Subject: RE: Mistletoe Farm, Horsemere Green Lane. CM/13/19/RES; Revised Drainage Proposals

Mistletoe Farm, Climping

Tree Retention & Protection Plan

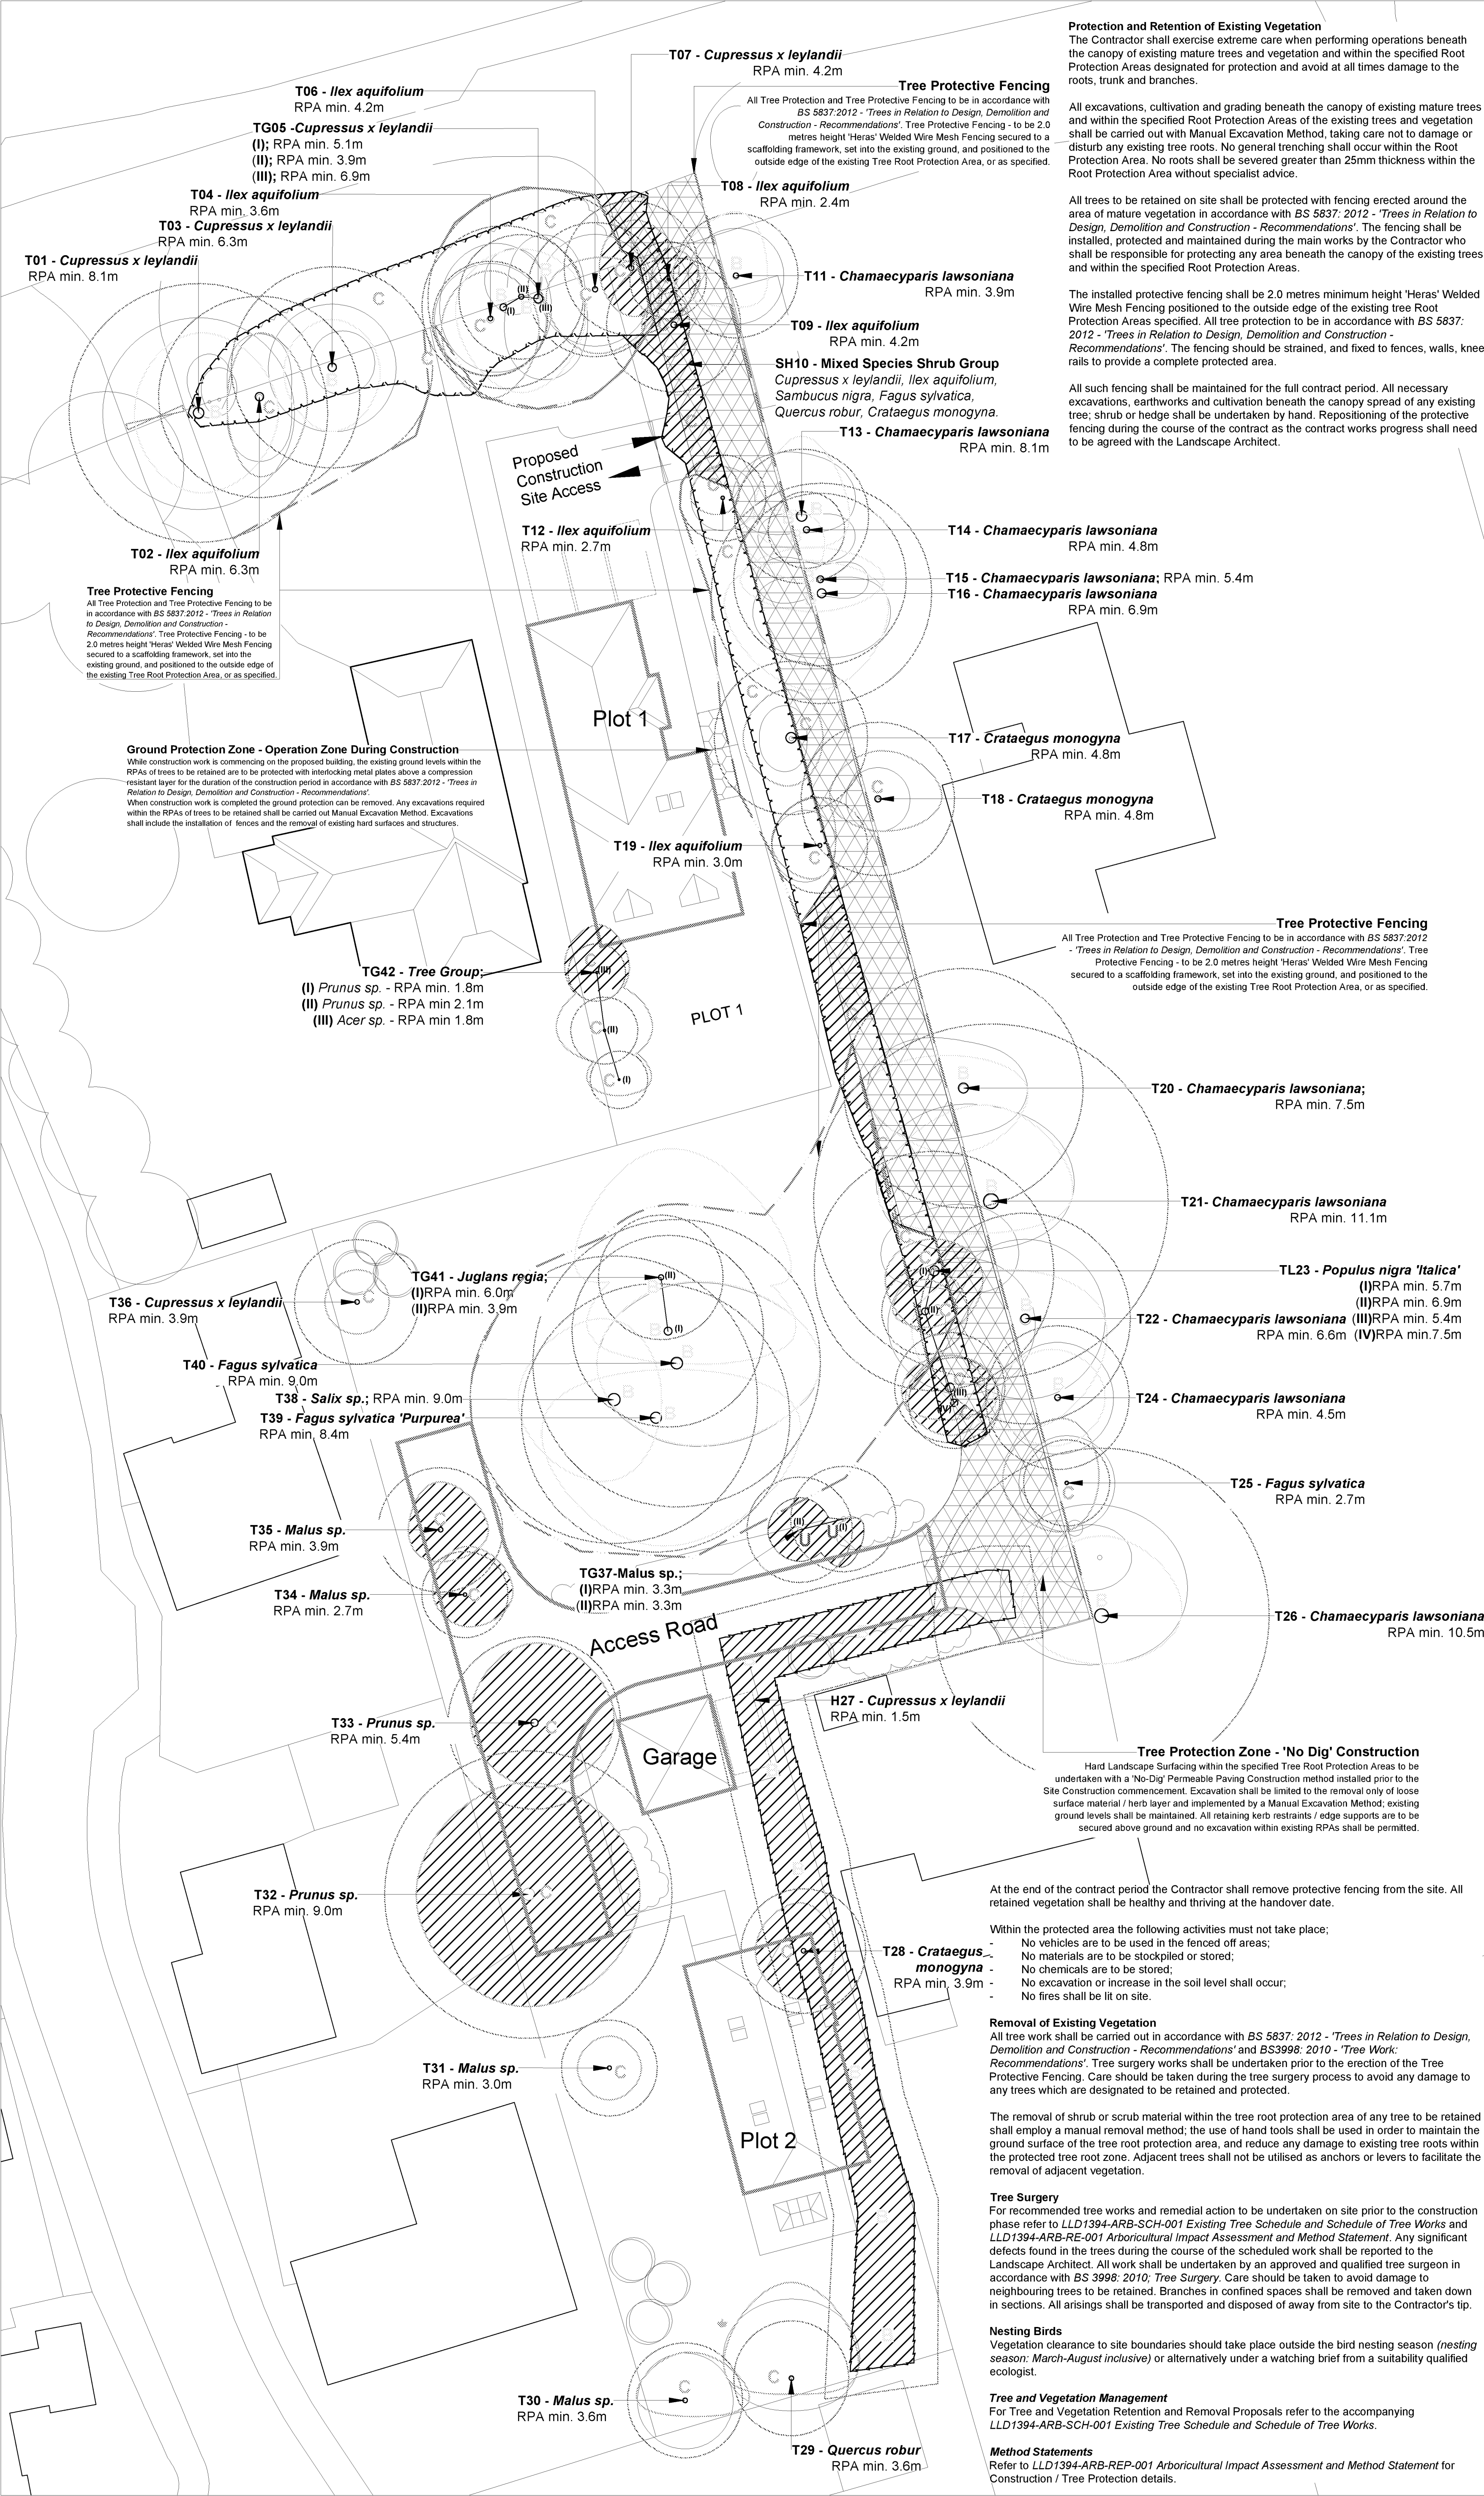
Thank you for sending over the revised plan. I believe there is some conflict between what you are proposing and the tree protection plan (attached).

The permeable paving for plot 2 looks like it could only be located in the T furthest round on the road rather than at the junction of roads 1 and 2. The swale also appears to be within a no dig area.
